NOTICE OF VIOLATION

INSPECTION REPORT

Electrical Corporation:	Pacific Gas and Electric				
Report Number:	ESD_PGE_RIB_20240911_1355				
Inspector:	Ramzi Ibrahim				
WMP Year Inspected:	2024				
Quarterly Data Report (QDR) Referenced:	Quarter 2 (Q2)				
Inspection Selection:	Energy Safety inspected the locations based on PGE's Q2 QDR.				
Relevant WMP Initiative(s):	8.2.3.2 Wood and Slash Management				
Date of inspection:	September 11, 2024				
City and/or County of Inspection:	Mariposa, CA				
Inspection Purpose:	Assess the accuracy of PG&E's QDR data, completeness of its work, compliance with WMP requirements, and				
	compliance with its protocols.

VMP ID: VP_BC125-H01_1632349_2020

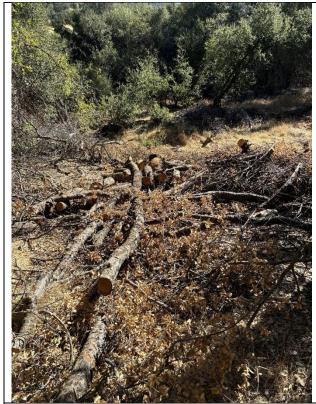
Energy Safety concludes that Violation 1 is "Moderate" because the slash pile is over 18-inches in height, creating a potential fuel source for wildfire.

photographs, which are exhibits to this report. Photo numbers Item1IA1Img1, Item1IA1Img2, depict a slash pile over 18-inches in height, and Item1IA1Img3, Item1IA1Img4 depict other slash, chips and woody debris associated with PG&E's work.

Violation 1

Item1IA1Img1: Pile of slash and woody debris is at least 18 inches in height and is approximately 26 inches in height in some places. Photograph taken from the east side of the pile.

Since Energy Safety's inspection, PG&E conducted a field visit on September 23, 2024, and completed the clean-up and disposal of wood and slash at 5549 Gold Creek Lane by September 25, 2024. Therefore, Energy Safety considers violation ESD_PGE_RIB_20240911_1355 closed. No further action from PG&E is required in response to this violation.
